SRC ENERGY

**RE: COGCC Rule 318A.e.: Proposed Wellbore Spacing Unit**

Bost Farm 26C-8-L  
API: 05-123-47691  
T5N-R66W Sec5: S/2S/2; Sec6: S/2S/2; Sec7: N/2N/2; Sec8: N/2N/2  
T5N-R67W Sec12: NE/4NE/4  
701.91 acres

## Spacing Unit Map

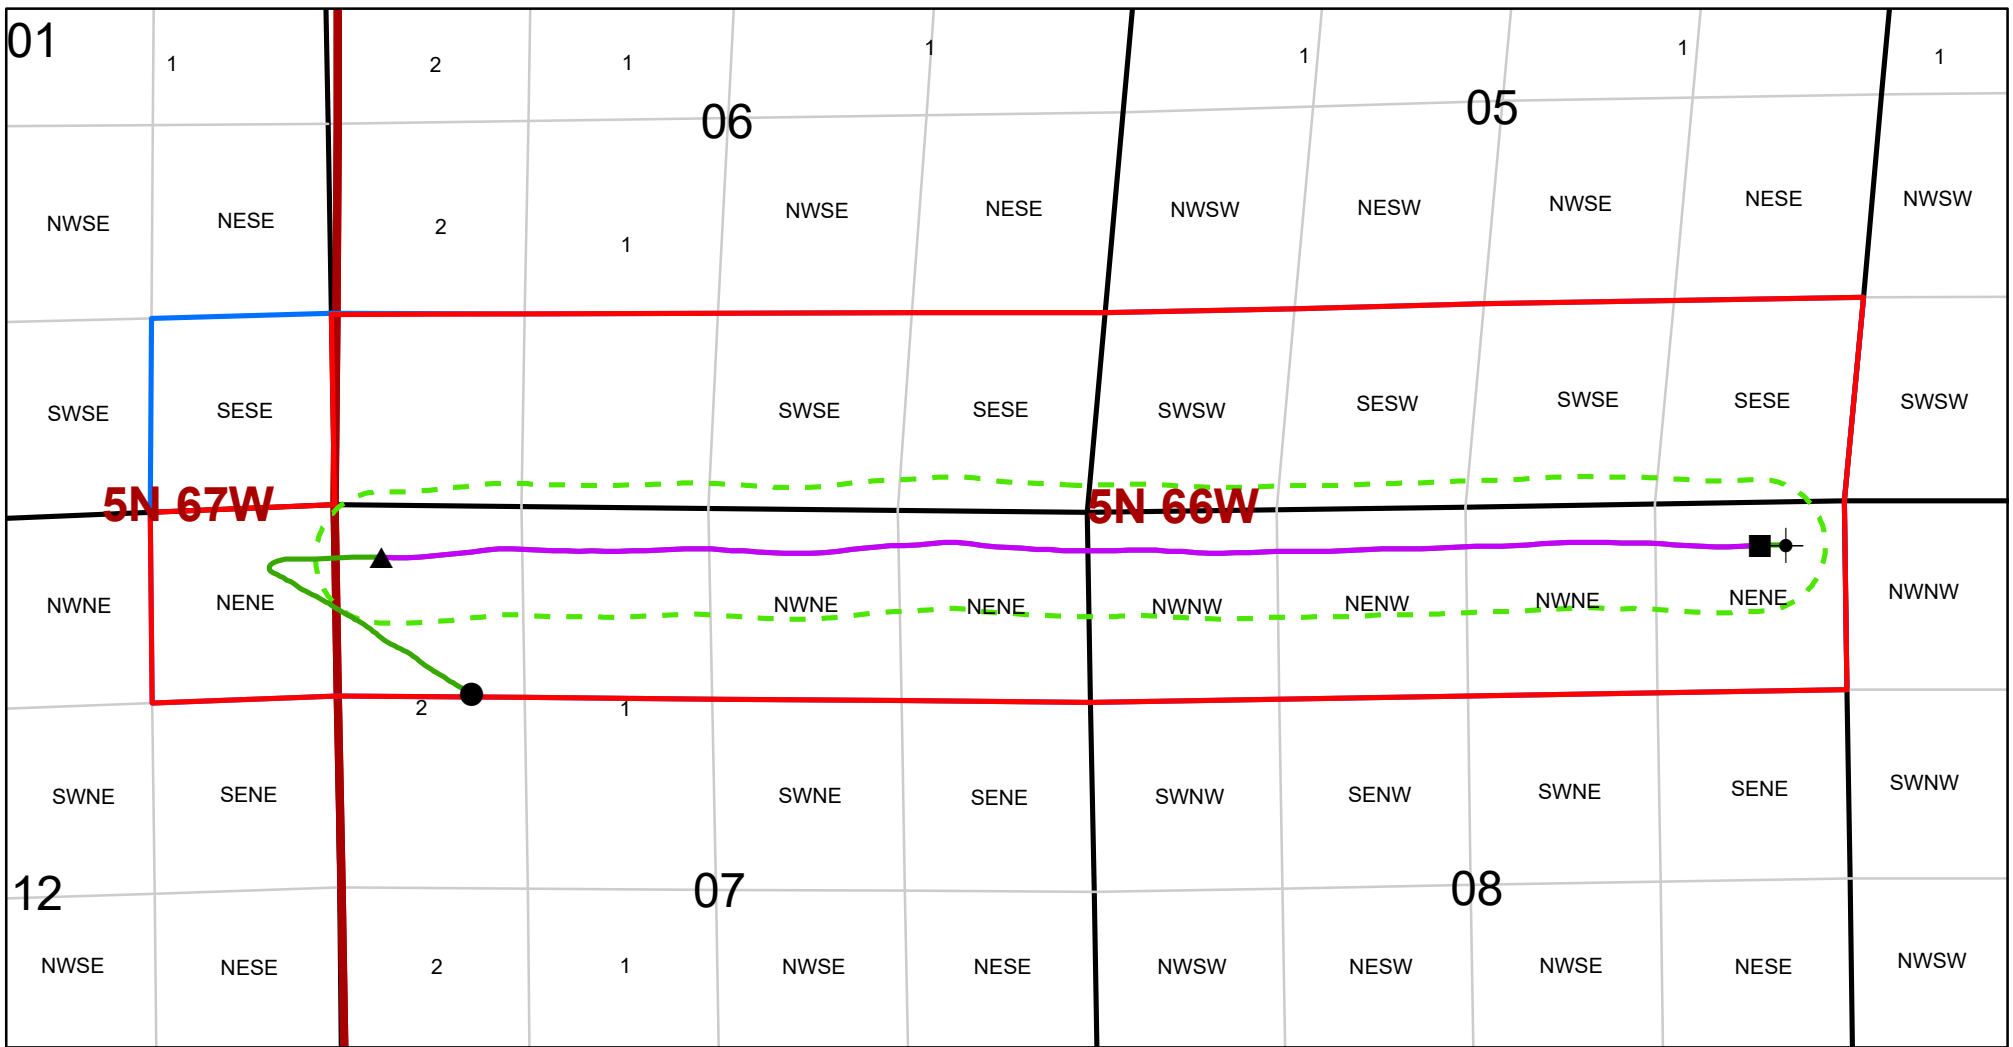
SRC Energy, Inc. ("SRC Energy") has drilled and completed the above referenced well. Although we were able to stay within our setbacks, we were unable to complete the permitted path and fell short of the originally approved wellbore unit and therefore need to modify the wellbore unit via a sundry Form 4. This sundry, and subsequent approval, will ensure SRC Energy becomes compliant with Rule 318A.e.

SRC Energy's updated proposed wellbore spacing unit consists of:  
Bost Farm 26C-8-L  
T5N-R66W Sec5: S/2S/2; Sec6: S/2S/2; Sec7: N/2N/2; Sec8: N/2N/2  
T5N-R67W Sec12: NE/4NE/4  
701.91 acres

Enclosed is the Proposed Spacing Unit Plat to assist in your review and approval of SRC Energy's proposed spacing unit change sundry, Form, 4 for Bost Farm 26C-8-L. SRC Energy respectfully requests the COGCC to review the enclosed information and approve this sundry Form 4 to revise the spacing unit for Bost Farm 26C-8-L.
